Diversified Metal Fabricators Service Bulletin SB 2052

Title	Locking Valve Leakage on Rear Railgear.
Document No.	SB-2052
Issue Date	10/08/2008 (SEW)
Units Affected	All rear railgear manufactured 1/2008 to 9/2008 with locking valves integral to the endcap of the rear hydraulic cylinders. (RW-1019, 1212, 1420, 1630, 1650)
Purpose	To address hydraulic fluid leakage from locking valves on rear cylinders.

FIG A

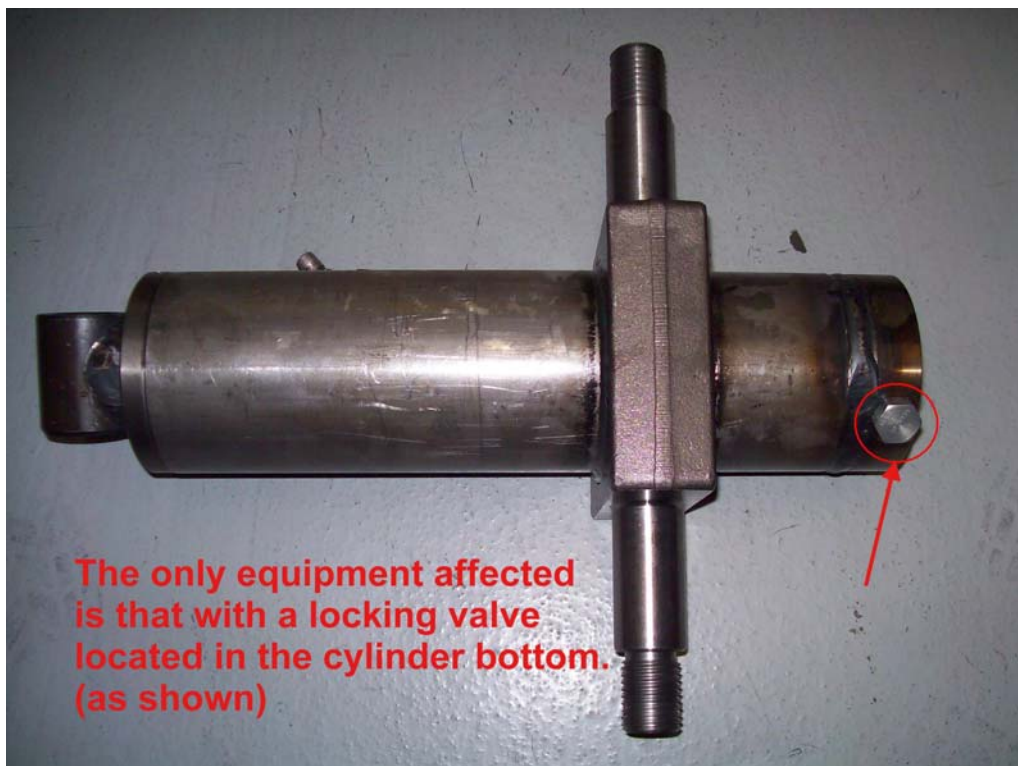
The cylinders covered under this service bulletin will have a HYDRA FORCE brand locking valve cartridge that is installed in a cavity integral to the cylinder bottom as shown in FIG A.

Manufacturing inconsistencies of the cylinder end cap with integral locking valve cavity MAY prevent the HYDRA FORCE brand cartridge from fully seating. The resulting effect is that the cylinder could either:

- A) Leak hydraulic fluid from around the cartridge or
- B) Allow the railgear to drift from rail or stowed position if mechanical locking pins are not used.

- On my rear rail gear, do my cylinders have a HYDRA FORCE locking valve integral to the cylinder end cap, as pictured in FIG A above?
- 2) If the answer to both questions is "yes" please inspect the area around the locking valve for leakage of hydraulic fluid. If you find fluid leaking from the locking valve you should call DMF at 404-875-1512 and press "1" for the parts department. Once connected with parts please tell them you are calling regarding Service Bulletin 2052. You will need to have two PARKER locking valves (DMF PART # 241015) shipped to your location. Please have the following information ready when you call in:

- 3) To replace the valves:
- Remove existing HYDRA FORCE locking valves
 - Inspect the cavity for any debris or other contamination.
 - Coat the new PARKER valves with hydraulic fluid paying particular attention to lubricate the seals well. (This is IMPORTANT!)
 - Start the new PARKER cartridges by hand, making as many turns as possible.
 - Tighten the cartridge to no greater than 15 FOOT POUNDS. Over torquing the valve can damage its internals and actually INCREASE likelihood of a leak.
 - Test railgear function and check for leaks.
- 4) If your railgear is covered under this service bulletin but is not currently experiencing any leakage or other problems, then please call DMF to determine if replacement is necessary.
